FINAL Carbon Basin Coal Project Environmental Impact Statement

FINAL
CARBON BASIN COAL PROJECT
ENVIRONMENTAL IMPACT STATEMENT,
CARBON COUNTY, WYOMING

**FINAL ENVIRONMENTAL IMPACT STATEMENT FOR THE
CARBON BASIN COAL PROJECT
CARBON COUNTY, WYOMING**

Figure 4.6 Air Quality CIAA - Annual PM₁₀ Emissions.

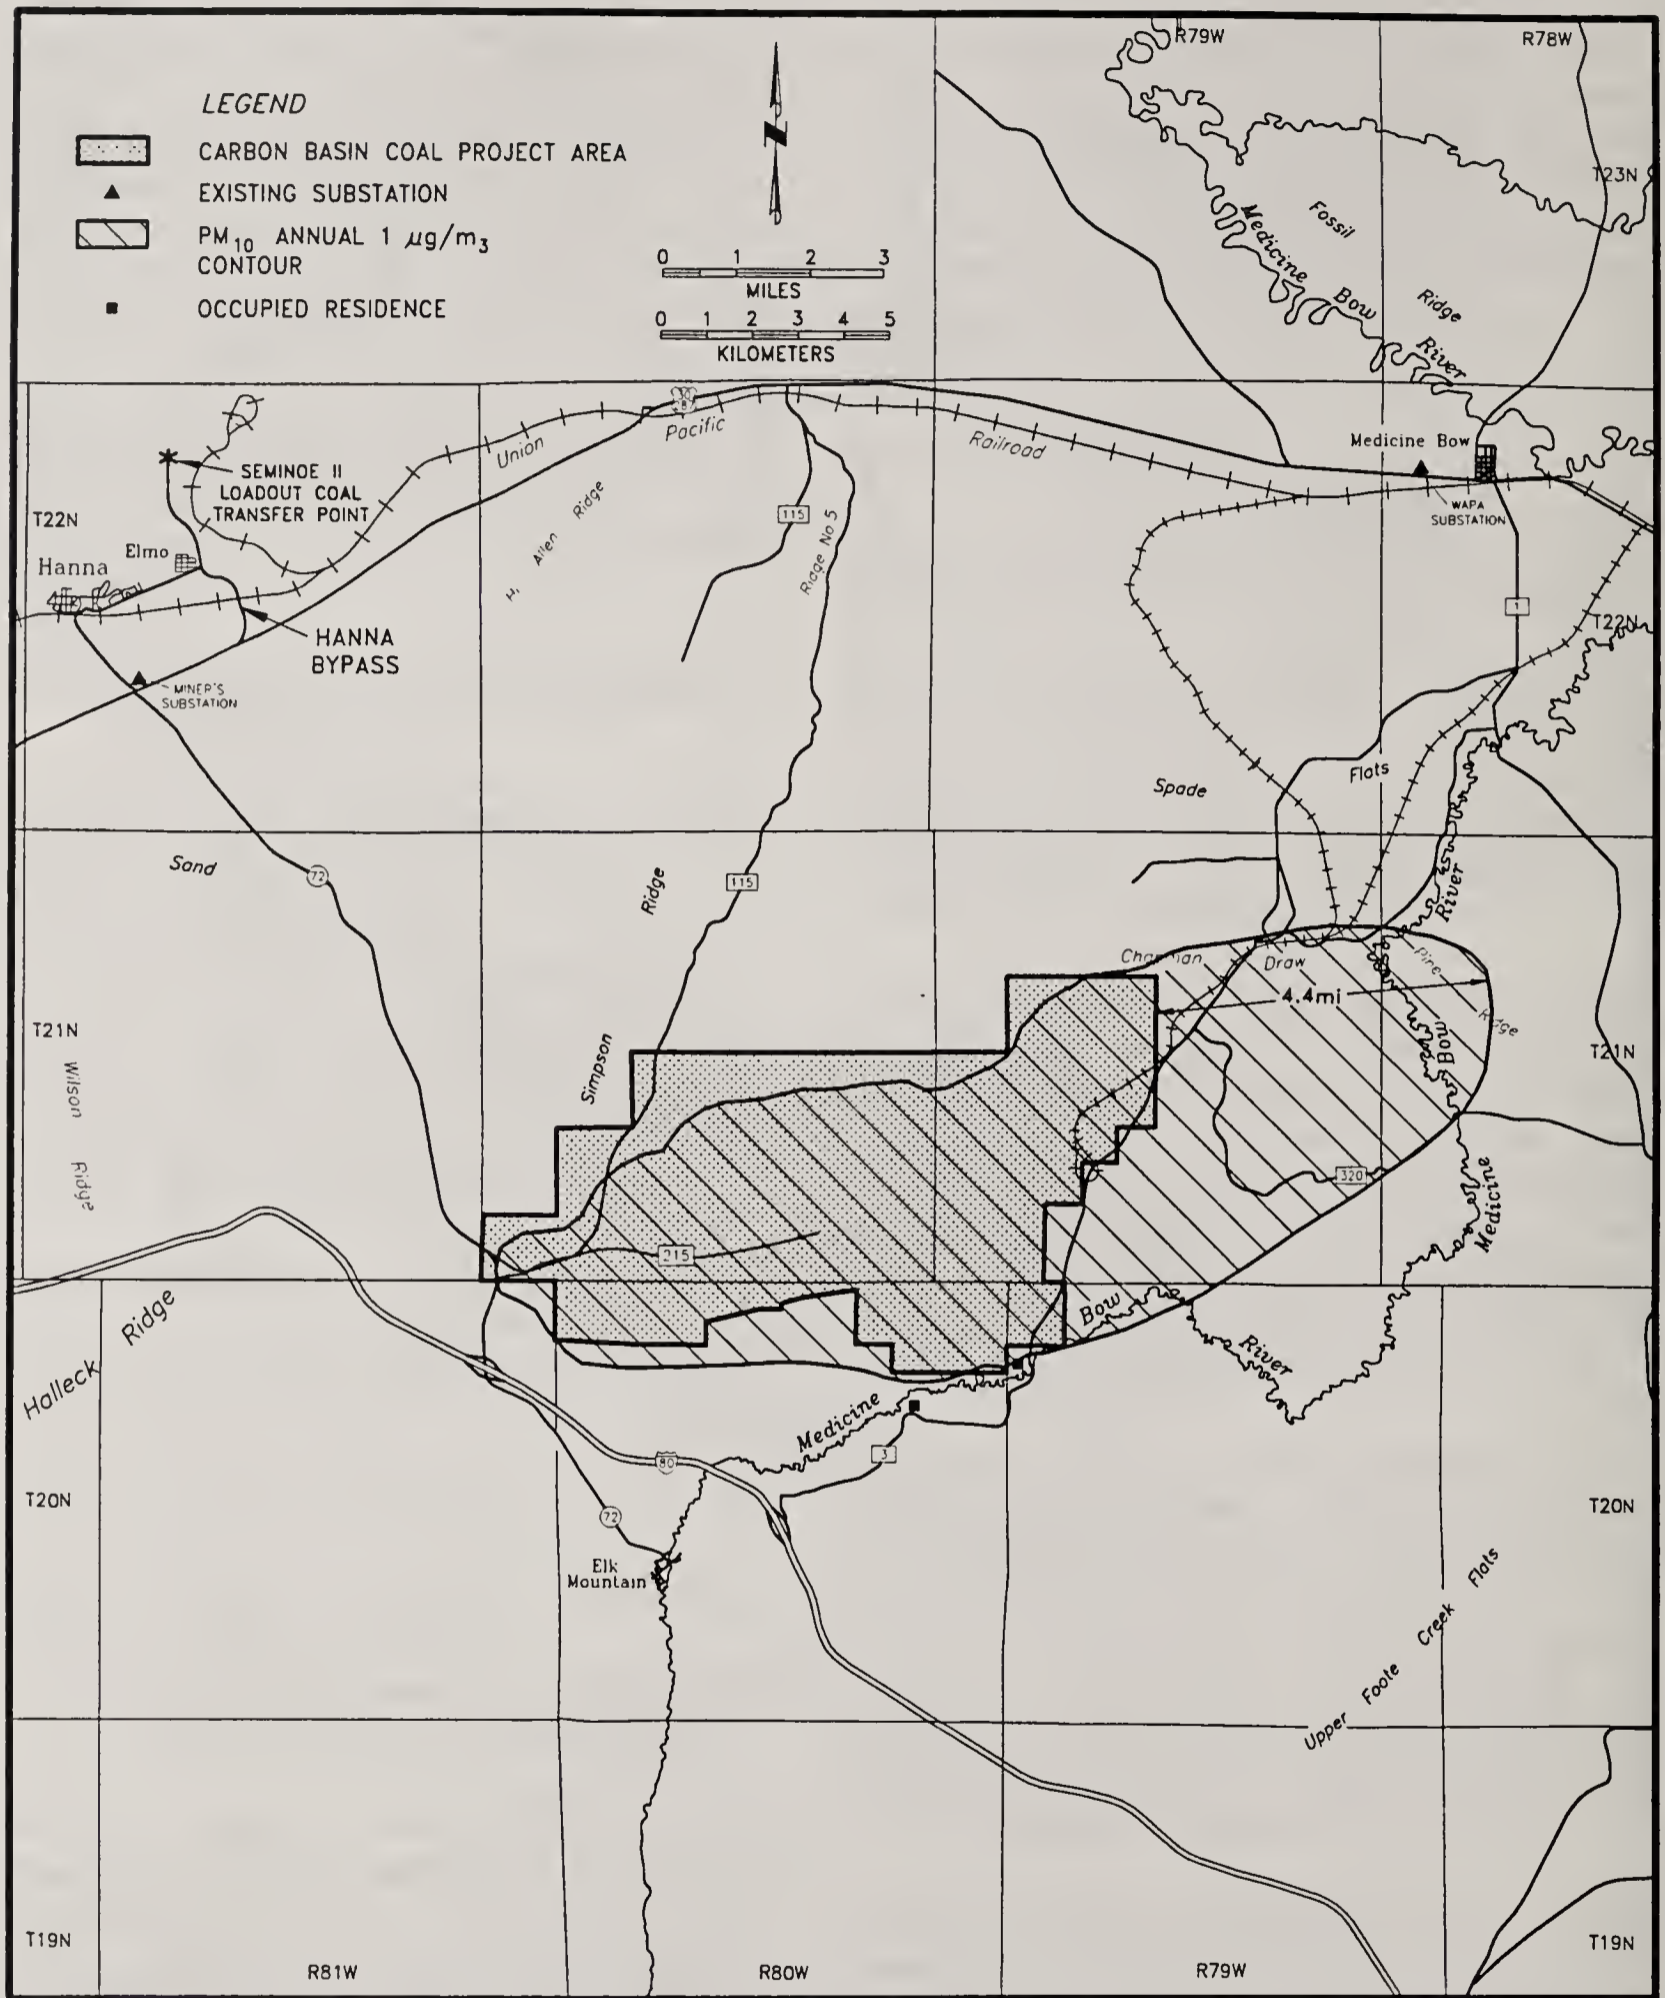
Pages 4-15 and 4-16, Figures 4.5 and 4.6. Replace with Figures 4.5 and 4.6 on the next page. "Figure 4.5 Air Quality CIAA - 24-hour PM₁₀ Emissions." "Figure 4.6 Air Quality CIAA - Annual PM₁₀."
